MFN 09-778, Revision 2

Subject: **Revised Response (Revision 2) to Portion of NRC Request for Additional Information Letter No. 391 Related to Design Control Document (DCD) Revision 6 – Fuel Racks - RAI Number 9.1-144**

**Revised Response (Revision 2) to Portion of NRC Request
for Additional Information Letter No. 391
Related to Design Control Document (DCD) Revision 6**

RAI Number 9.1-144

Figure 1-1. Layout of Fuel Support Racks and Base Plates

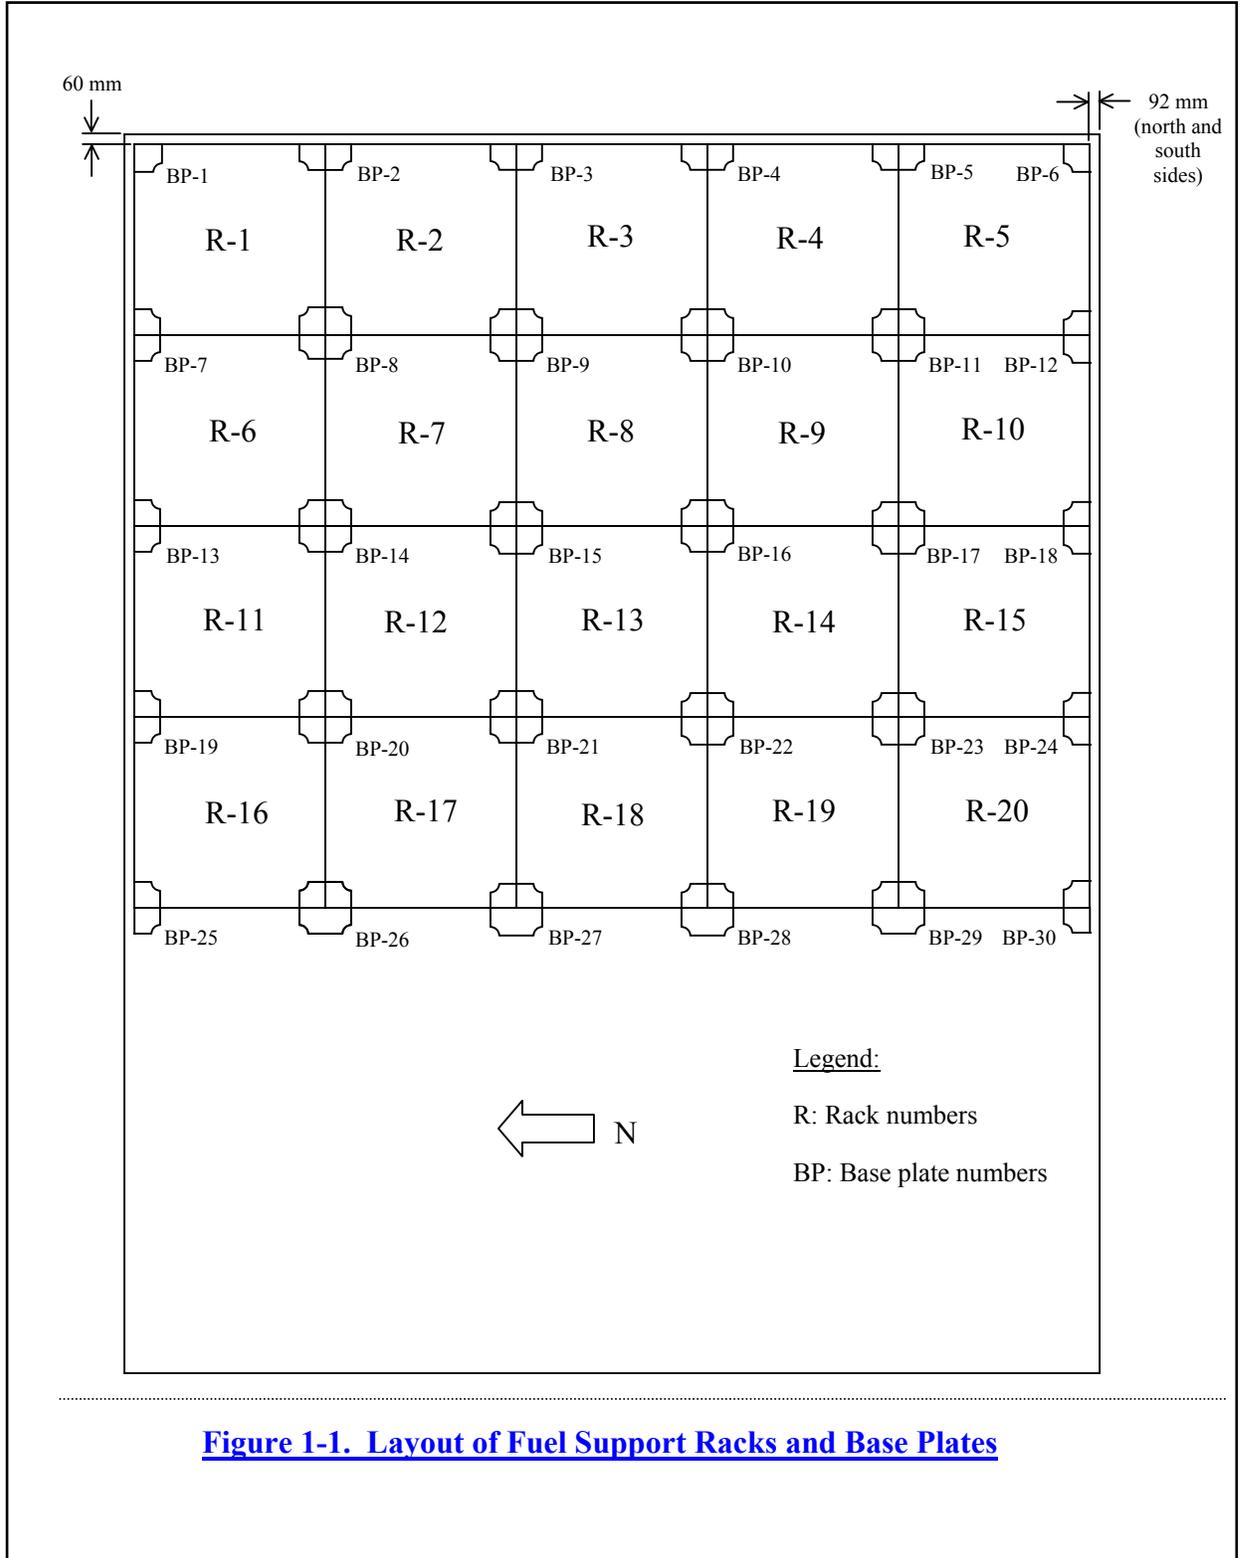
- 1) the applicant provide justifications for not including the T_a in ASME Service Level D load combination, and demonstrate the racks will not impact the pool wall liners during an SSE event concurrent with T_a ;*
- 2) the applicant demonstrate the effect of thermal gradient based on the Service Level D load combination will not impact the functionality of the racks by following the guidance provided in Section 1.4 (the 3rd sentence of the 1st paragraph) of Appendix D to SRP 3.8.4.*
- 3) Provide clarification of terms used in Section 1.6.5.1 such as R-16, BP-26, etc., which can be best illustrated by providing a schematic plan view of the layout of racks in the pool including the gaps with the pool walls.*

- 3) LTR NEDC-33373P Figure 1-1 is added to provide clarification of terms used and illustrate by providing a schematic plan view of the rack and base plates in the pool including the gaps with the pool walls as shown in the attached markup.

[The layout of the FSR and the associated base plates is shown in Figure 1-1.](#) The FSR are structures fabricated from stainless steel and borated stainless steel plates forming cells to house the spent fuel assemblies. The FSR are freestanding racks on the floor of the Spent Fuel Pool at EL -10000. The analysis evaluates the ten-year fuel storage configuration. Twenty (20) FSR will be located in the Spent Fuel Pool, providing a total of 3504 storage spaces. Two sizes of FSR are analyzed: 15x12 cell and 14x12 cell.
